FLOOR TO CEILING DETAILS

Within apartments only. Refer to dwgs 112-116 for ceiling heights

Floor Detail 1

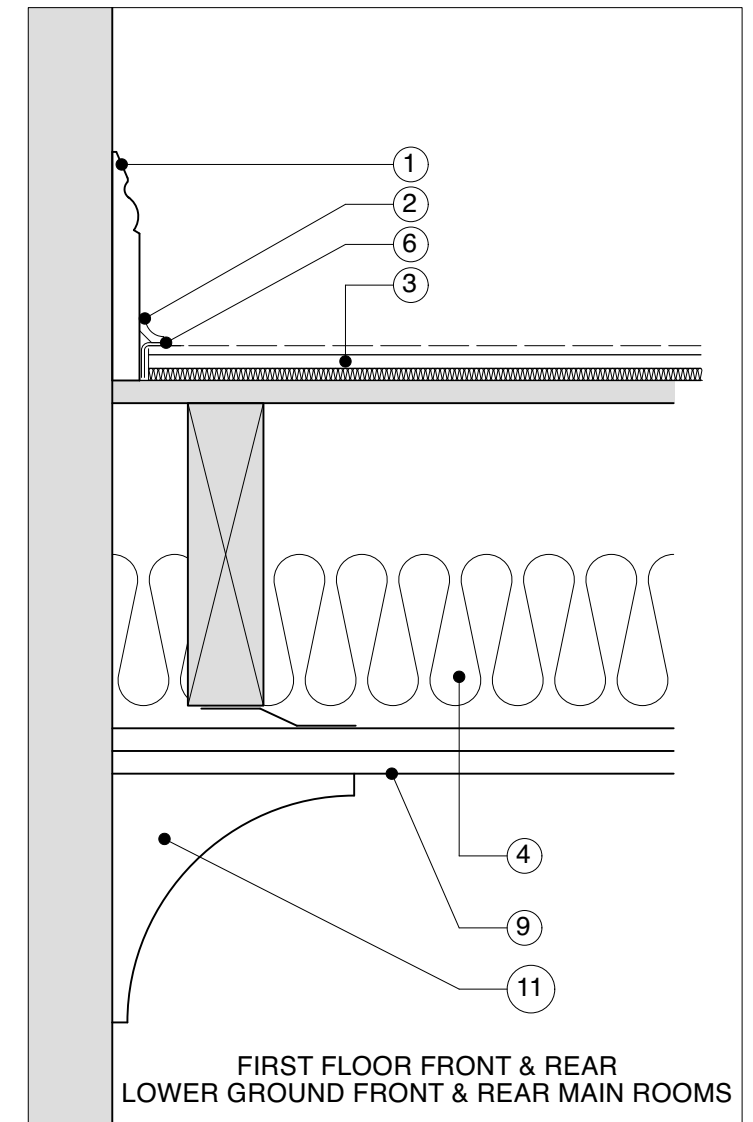
Existing skirting to remain in place, scotia trim added to floor perimeter.
FF Rear room changed from Detail 3 to Detail 4.
SF Front room amended from Detail 4 to Detail 1.
